PLANNING BOARD AGENDA
JULY 14, 2022 – 7:00 P.M.

RE: Amended Site Plan
PGI, LLC Endoscopy Center
667 Stoneleigh Avenue
TM#: 66.15-1-3

The following is my response to Mike Carnazza's memo dated 6/21/2022:

STONELEIGH AVENUE
SITE PLAN
1" = 20'-0"

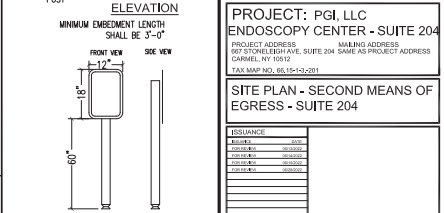
1. The total number of parking spaces will remain at 194.
2. A planting schedule has been added to the Site Plan.
3. The existing exterior lighting will be relocated as shown on the Site Plan.

NOTE: 1. ALL NEW PLANTINGS SHOULD BE VERIFIED WITH THE TOWN OF CARMEL WETLANDS INSPECTOR.
2. ALL PLANTINGS SHALL BE INSTALLED PER SECTION 142 OF THE TOWN OF CARMEL TOWN CODE.

PARKING SPACES	TYPE
162	REGULAR
16	HANDICAP
194	TOTAL

NEW SECOND MEANS OF EGRESS - SUITE 204 & ENLARGED SITE PLAN

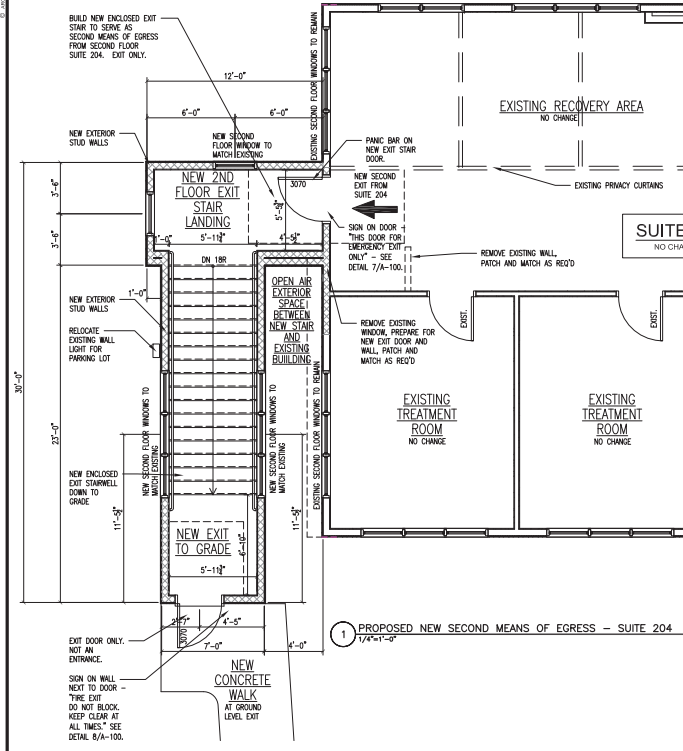
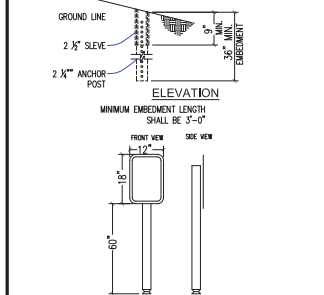
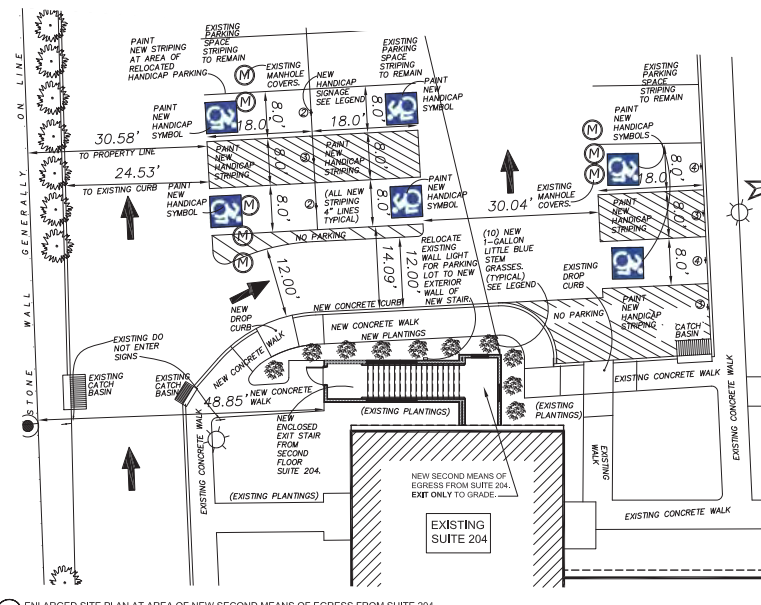
1. The traffic pattern will remain the same as it is now.
2. There are no other suites that will require a second means of egress.
3. The oval shape has been placed on the drawings at a larger scale.
4. The path of egress has been added to the drawings.
5. The path to the building from the accessible parking spaces has not changed.
6. The detail of the stair and the landing have been added to the drawings.
7. The exterior elevations is on the drawings.
8. The pharmacy space has been vacant for several years. However, the parking calculations have been revised to reflect this space for future retail use.
9. The means of egress for the existing space has been added to the drawings.
